RENESAS TECHNICAL UPDATE

Product Category	MPU/MCU	Document No.	TN-RX*-A0268A/E	Rev.	1.00
Title	Errata to the RX26T Group User's Manual: Hardware Rev.1.01		Information Category	Technical Notification	
Applicable Product	RX26T Group	Lot No.	Reference Document	RX26T Group User's Manual: Hardware Rev.1.01 (R01UH0979EJ0101)	
		All

This document describes corrections to the RX26T Group User's Manual: Hardware Rev.1.01.

CSCMSC[2:0] Bits (Compare Match/Input Capture/Synchronous Counter Clearing Source Counter Clear Enable)

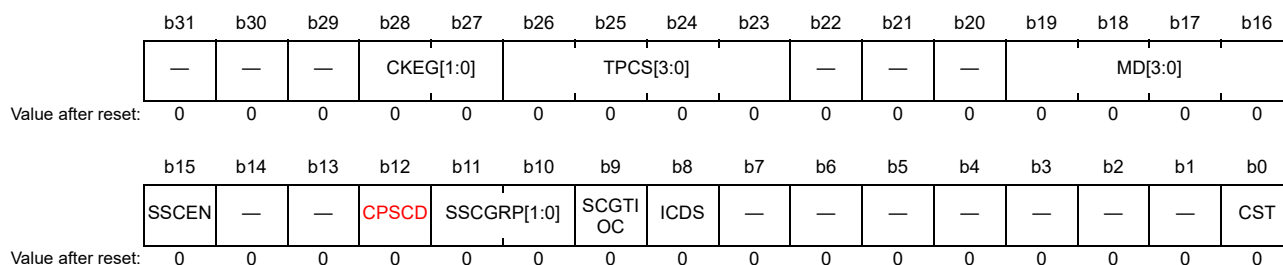
The descriptions for the CSCMSC[2:0] bits in section 24.2.7, General PWM Timer Clear Source Select Register (GTCSR), are modified as follows.

Select whether to enable or disable for the counter clear of the GTCNT counter by compare match/input capture/synchronous counter clearing group. **When counter clearing in response to a match in comparison or input capture is enabled, either can be used as a source for synchronous clearing by inter channel cooperation as described in section 24.3.8.3, Synchronous Clear Operation by Inter Channel Cooperation. When counter clearing by input capture is enabled while the setting of the CSCMSC[2:0] bits is 001b or 010b, the same sources for input capture as one set in the GTICmSR (m = A, B) register must be set as the counter clearing sources in the GTCSR register. Note that input capture on other channels cannot be used as the source to drive counter clearing, that is, the GTICASR.ASOC or GTICBSR.BSOC bit cannot be set to 1.**

Figure 35.48 I3C Target Receives GET CCC Command while Data Exists by Writing from the ICDR Register to the Transmit Buffer

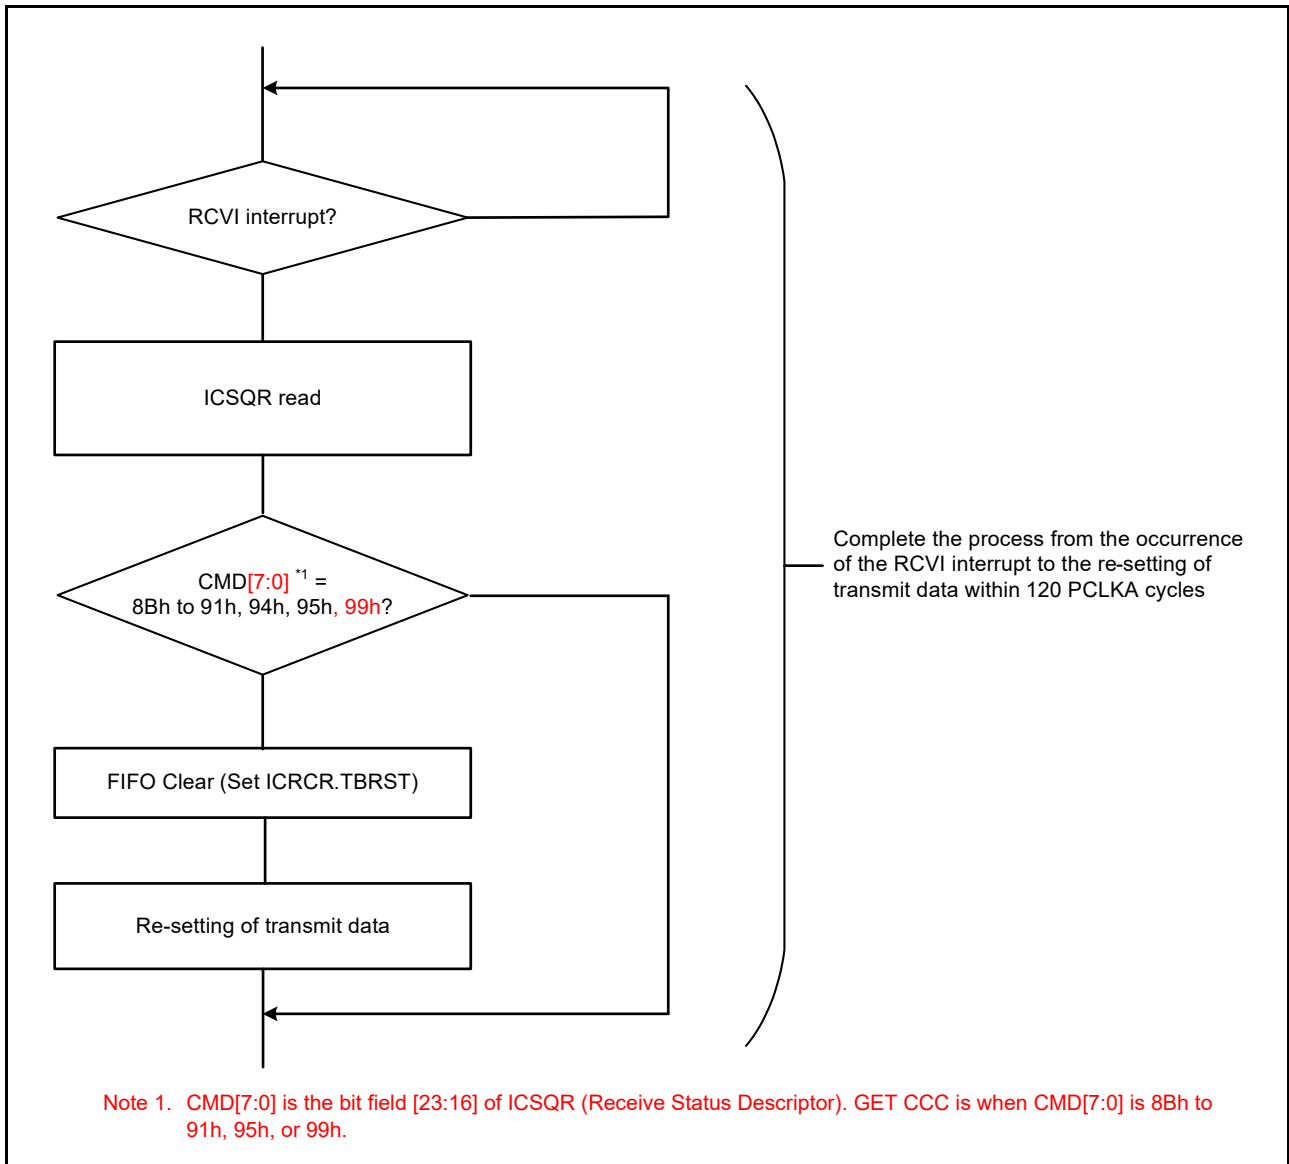
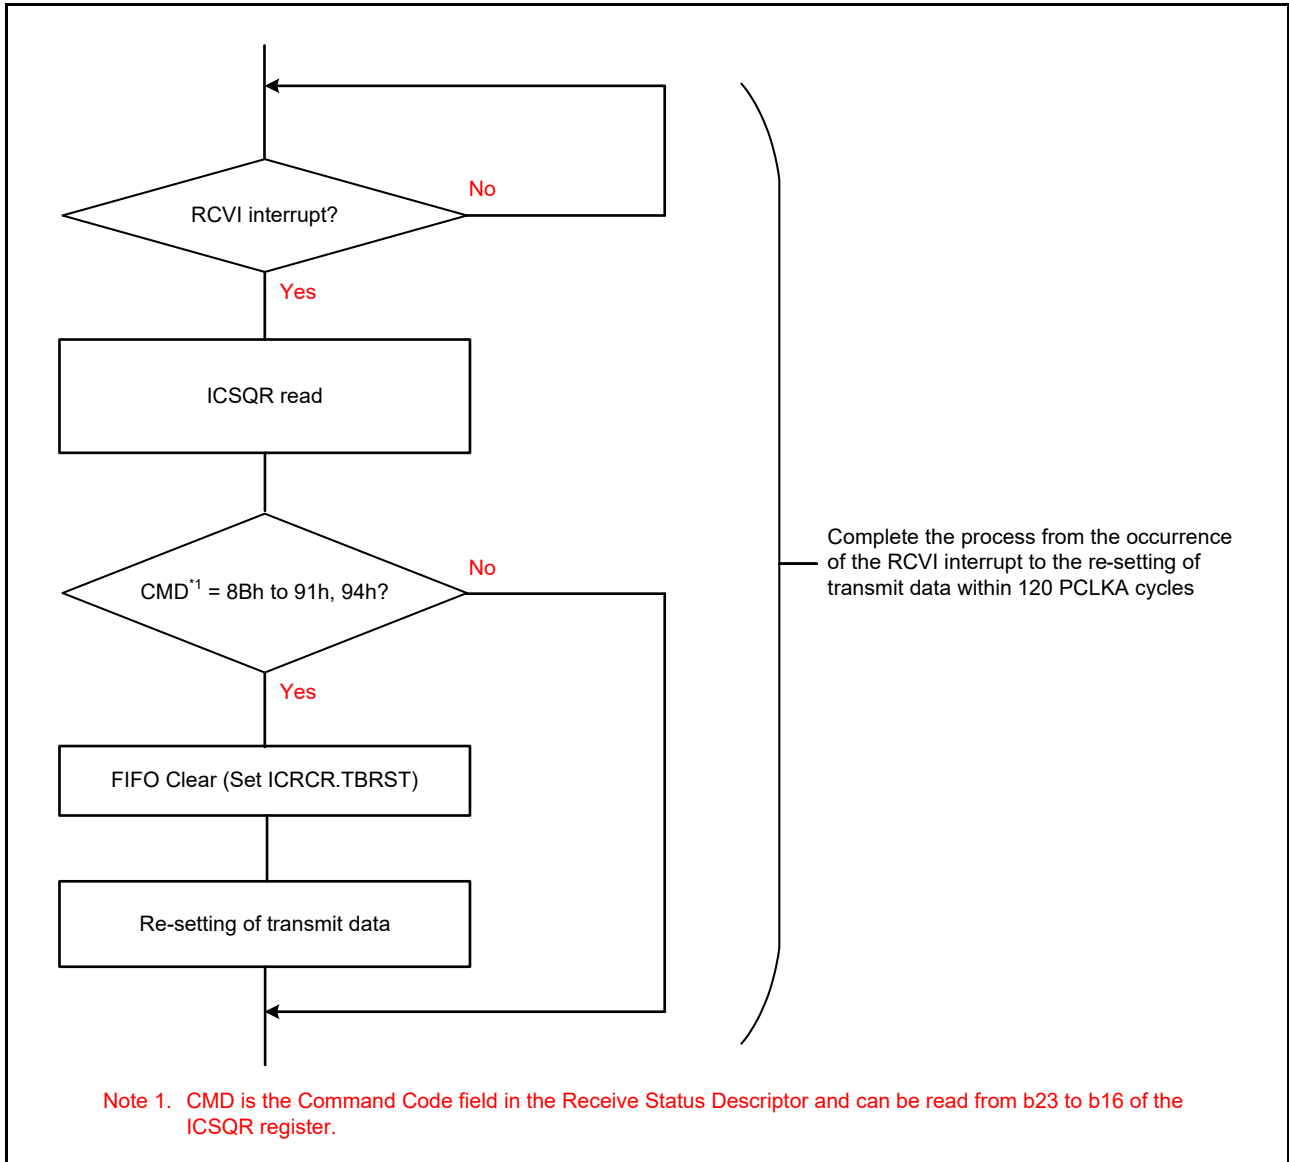
Figure 35.48 in section 35.4.6.5, I3C Target Transmission Flow (FIFO Buffer Transfer), is corrected as follows.
